# Final Programmatic **Environmental Impact Statement**

related to decontamination and disposal  
of radioactive wastes resulting from

Three Mile Island Nuclear Station, Unit 2

NUREG-0683  
Vol. 2  
Appendices A-Z

Figure 6.2.1 Flow Diagram for Purge Using Hydrogen Control Subsystem

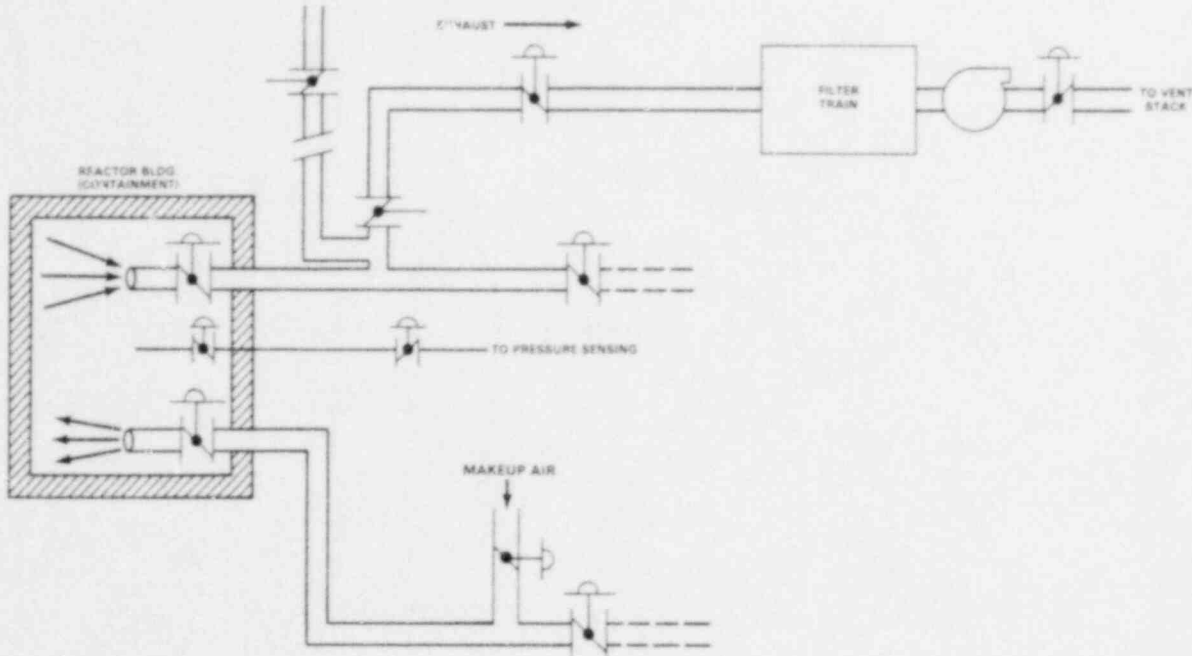
MW = Monitoring Well (pumped samples)
49. Figure 6.4-1  
Figure 6.4-2 - The inclusion of these figures should not preclude alternative designs. The reference to "air tight" doors on the figures should be deleted.
